PROPOSED TECHNICAL SPECIFICATION (TS) CHANGE

SEQUOYAH NUCLEAR PLANT (SQN) UNITS 1 AND 2

(TVA-SQN-TS-93-09, REVISION 1)

REVISED LOSS-OF-POWER INSTRUMENTATION SETPOINTS

TABLE 3.3-4 (Continued)

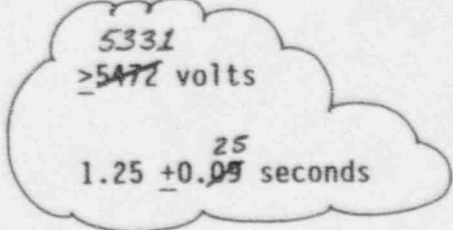
FUNCTIONAL UNIT	TRIP SETPOINT	ALLOWABLE VALUES
7. LOSS OF POWER		
a. 6.9 kv Shutdown Board Undervoltage		
Loss of Voltage		
1. Voltage Sensors	≥ 5520 volts	 <p>5331 >5472 volts</p>
2. Diesel Generator Start and Load Shed Timer	1.25 seconds	 <p>1.25 ²⁵ +0.09 seconds</p>
b. 6.9 kv Shutdown Board-Degraded Voltage		
1. Voltage Sensors	6456 volts	 <p>>6403.5 volts (dropout) <6626.5 volts (reset) - 6595.5</p>
2. Diesel Generator Start and Load Shed Timer	≤ 300 seconds	 <p>370 <321 seconds</p>
3. SI/Degraded Voltage Logic Enable Timer	 <p>9.5 10 seconds</p>	 <p>9.5 ^{2.0} seconds + 0.75 seconds</p>
8. ENGINEERED SAFETY FEATURE ACTUATION SYSTEM INTERLOCKS		
a. Pressurizer Pressure		
1. Not P-11, Automatic Unblock of Safety Injection on Increasing Pressure	≤ 1970 psig	≤ 1975.2 psig
2. P-11, Enable Manual Block of Safety Injection on Decreasing Pressure	≥ 1962 psig	≥ 1956.8 psig

- Item 7.a of TS Table 3.3-4 allowable values for the voltage sensor and timer would be revised. The allowable value for the voltage sensor will be changed to ≥ 5331 volts. The allowable value for the D/G start and load shed timer will be changed to 1.25 ± 0.25 seconds.

- Item 7.b of TS Table 3.3-4 trip setpoint and allowable values for the voltage sensor and timers would be revised. The allowable value for the voltage sensor reset will be changed to ≤ 6595.5 volt. The allowable value for the D/G start and load-shed timer will be changed to ≤ 370 seconds. The trip setpoint for safety injection (SI)/degraded voltage logic enable timer will be changed to 9.5 seconds. The allowable value for the D/G degraded voltage logic enable timer will be changed to 9.5 ± 2.0 seconds.

- The proposed loss-of-voltage sensor allowable value revision will utilize a limit that is based upon the safety analysis limit. The original allowable value was determined based on expected instrumentation tolerances and was overly conservative with respect to the analysis limit. The use of the original allowable value could have resulted in unnecessary reporting of conditions violating the allowable value even though the safety limit was not at risk.

- The proposed loss-of-voltage timer allowable value was revised for the same reasons described for the loss-of-voltage sensor allowable value above. In addition, these timers were to be replaced with a more accurate electronic timer, but will now remain with the electro-pneumatic version. This resulted in an allowable value in the original proposal that the revised design cannot achieve because of the original dependence on the expected instrumentation capabilities instead of analysis limits. Maintaining the present electro-pneumatic timers will significantly reduce the implementation time by eliminating field work to replace the relays.

- The proposed degraded voltage sensor allowable value for reset change will agree with the latest voltage analysis performed for SQN. The SQN voltage analysis is periodically reperformed to account for plant modifications as well as changes to the offsite power system. One of these reevaluations occurred after the original request was submitted and a slight change to this allowable value resulted.
